APPLICATION NO.	FILING DATE	FIRST NAMED INVENTOR	ATTORNEY DOCKET NO.	CONFIRMATION NO.
09/739,582	12/15/2000	Steven Teig	SPLX.P0005	3530

Office Action Summary

DETAILED ACTION

Regarding claim 16, Jones et al. discloses in Fig. 7C an integrated circuit comprising:

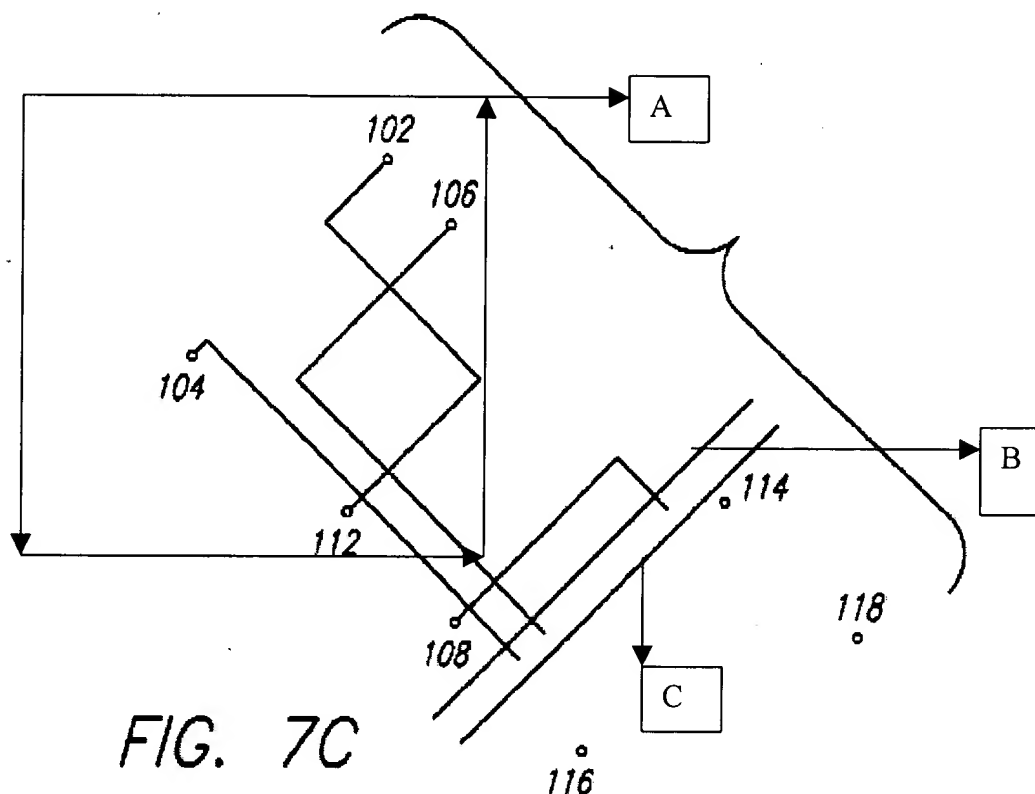
4. Claims 16 ~ 23 and 28 ~ 35 are rejected under 35 U.S.C. 102(b) as being anticipated by Jones et al.

- a plurality of metal layers (102, 104 106, etc.) comprising a plurality of conductors to interconnect components in an integrated circuit, said metal layers comprising:

- a first metal layer group (102, 104 and 106) comprising at least one metal layer, said metal layer in said first metal layer group comprising at least one self contained layout section (A in Fig. 7C in the next page) comprising conductors deposited in a preferred Manhattan direction (106), wherein a preferred direction defines a direction, relative to the integrated circuit boundaries, for at least fifty percent of conductors, and said self contained layout section comprising a routing of conductors developed independent (104) from routing of conductors for circuits outside said self contained layout section in said integrated circuit.; and

- a second metal layer group (B and C) comprising at least one metal layer, said metal layer in said second metal layer group comprising a plurality of conductors deposited in a preferred diagonal direction in a portion of the metal layer directly adjacent to said portion of said metal layer for said self contained layout section, and wherein conductors for said second metal layer group are routed independent from routing of conductors for said self contained layout section.

Regarding claims 17 and 29, Jones et al. discloses in Fig. 7C said self contained layout section being independent of a layout for said second metal layer group.

Regarding claims 18 and 30, Jones et al. discloses in Fig. 7C a plurality of self contained layout sections in said first metal layer.

Regarding claims 19 and 31, Jones et al. discloses in Fig. 7C at least one of said self contained layout sections comprising a wiring direction perpendicular to a wiring direction of a second one of said self contained layout sections.

Regarding claims 20 and 32, Jones et al. discloses in Fig. 7C said self contained layout section comprising an entire one of said metal layer in said first metal layer group.

Regarding claims 21 and 33, Jones et al. discloses in Fig. 7C said first metal layer group comprising three metal layers.

Regarding claims 22 and 34, Jones et al. discloses in Fig. 7C said three metal layers each comprising conductors deposited in preferred Manhattan directions, wherein said first metal layer comprises a preferred Manhattan direction complementary of a preferred Manhattan direction of said second metal layer; and said second metal layer comprises a preferred Manhattan direction complementary of a preferred Manhattan direction of said third metal layer.

Regarding claims 23 and 35, Jones et al. discloses in Fig. 7C said diagonal direction comprising a direction 45 degrees relative to said integrated circuit boundaries.
